City of Chewelah

Civic Center Improvements

The Civic Center

Figure 10

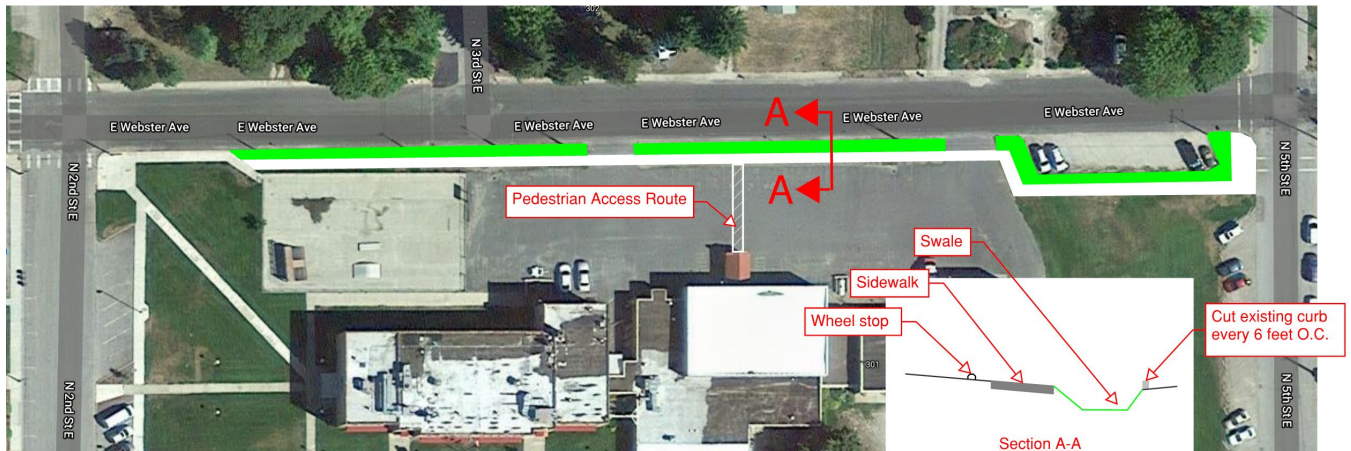
5. Accessibility to the site from E Webster Ave is not currently provided as there is no sidewalk on the southern side of the street from N 2nd Street E to N 5th Street E. It is recommended that a sidewalk be added along with a pedestrian pathway to the northern building entrance per Figure 10 below. Stormwater runoff from the northern parking lot currently sheet flows to the north into a grass depression. Once a sidewalk is added, it is recommended a swale be added between the sidewalk and curbing to provide water quality treatment for the stormwater runoff of both the road and parking lot. See Section A-A on Figure 10. Approximate cost of improvements: \$50,000 - \$75,000

Figure 4

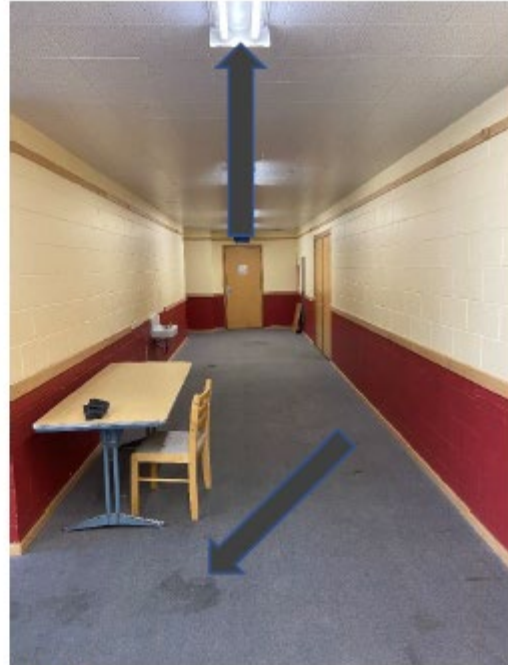
In figures 3-7 show the condition of the lobby. It is recommended the ceiling tiles be replaced, and warmer recessed led lighting be added in the ceiling tiles. The carpet should be replaced, carpet tiles are recommended for acoustics, maintenance, cost and longevity. It is recommended this space in its entirety be painted a lighter color with a durable low VOC paint, consider removing or painting the existing wooden chair rails an accent color. It is recommended that all the interior doors and hardware be replaced with durable and ADA compliant selections. All bathroom signage needs to be brought up to ADA standards. The drinking fountain needs to be brought up to ADA compliance below in figure 8. The ROM in terms of cost for this suggestion is between \$30K-\$100K.

Figure 13

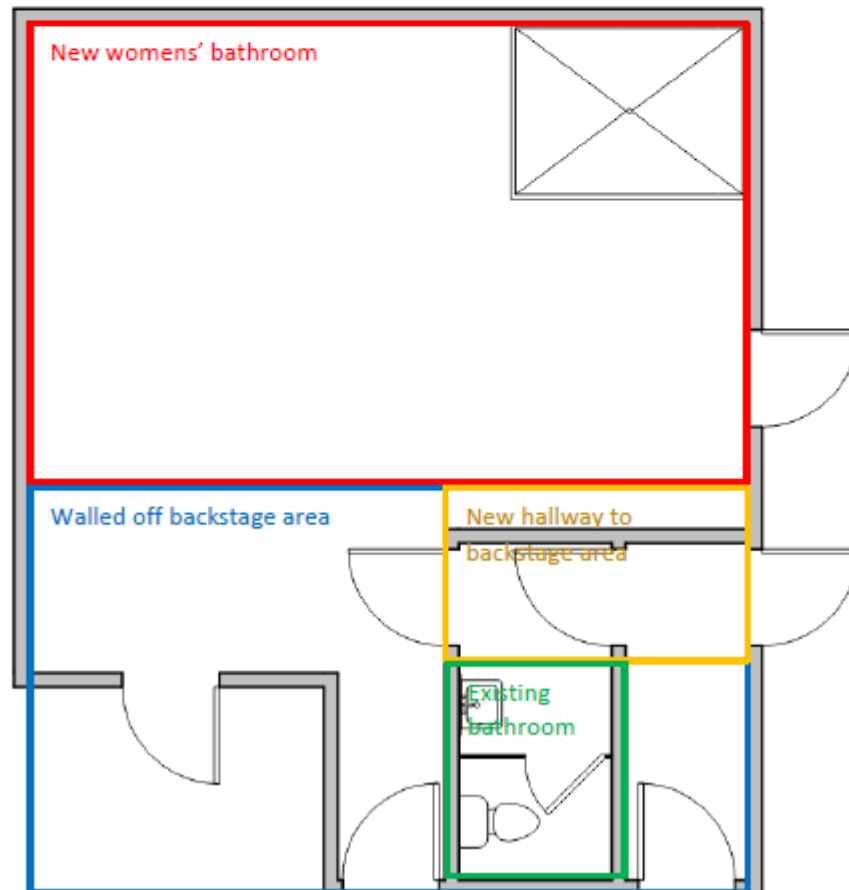
Figures 13-17 show the gymnasium's original girls' locker and bathroom spaces. The asbuilt diagram is for broad planning purposes and needs to be field verified before any architectural work commences. It is suggested that completely renovated, modern bathrooms meeting ADA standards be designed and constructed in this existing space, the area in red. Full architectural services will be required for this scope of work including an in depth code review, in the absence of more information it is anticipated two stalls, one of which is ADA compliant will be required per gender of bathroom. The ROM in terms of cost for this suggestion is between \$50K-\$80K.

Figure 19

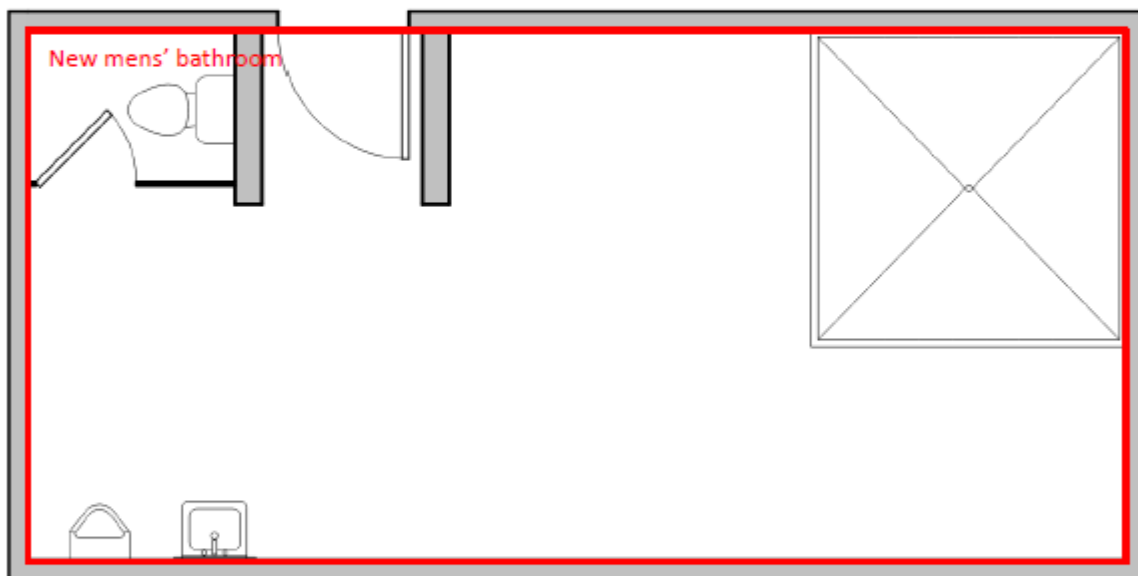
Figures 19-22 show the gymnasium's original boys' locker and bathroom spaces. The asbuilt diagram is for broad planning purposes and needs to be field verified before any architectural work commences. It is suggested that completely renovated, modern bathrooms meeting ADA standards be designed and constructed in this existing space. Full architectural services will be required for this scope of work including an in depth code review, in the absence of more information it is anticipated two stalls, one of which is ADA compliant will be required per gender of bathroom. It is also suggested the mens' bathroom access be relocated to the existing closed off opening located in the lobby hall, for ADA and general bathroom access to be consistent for both genders from the lobby. The ROM in terms of cost for this suggestion is between \$50K-\$80K.

Figure 23

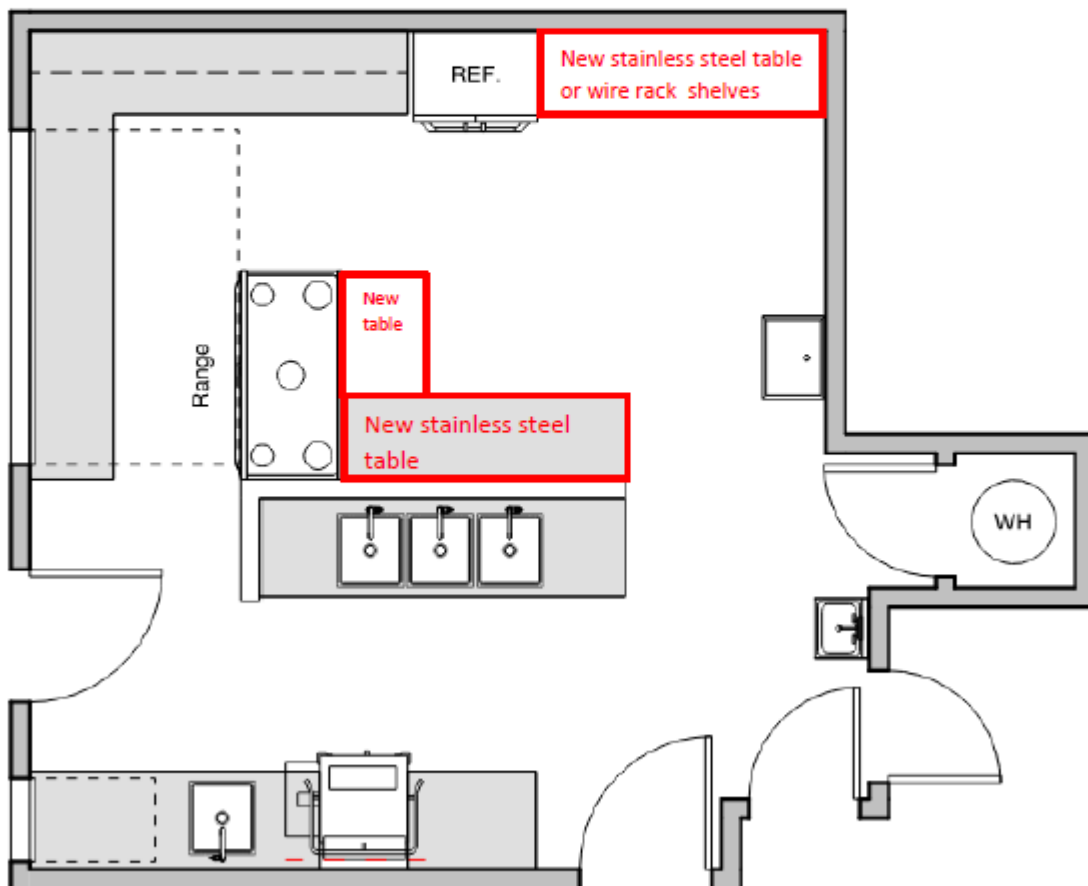
Figures 23-27 show the commercial kitchen adjacent to the gymnasium space. The asbuilt diagram is for broad planning purposes and needs to be field verified before any architectural work commences. Generally, the kitchen is in good condition. It is suggested that the backsplash areas and the half wall perpendicular to the range be wrapped in a wipeable surface such as fiberglass reinforced panels (FRP), remove the cabinetry on the half wall and replace with a stainless steel table, also consider putting one parallel and against the cooktop, and one next to the fridge. It is suggested the remaining existing cabinetry be painted with a high gloss wipeable paint, replace the hardware, replace the flooring, paint the walls and ceiling, replace the fridge. It is also suggested to have the health department inspect and provide compliance guidance. The ROM in terms of cost for this suggestion is between \$15K-\$30K.
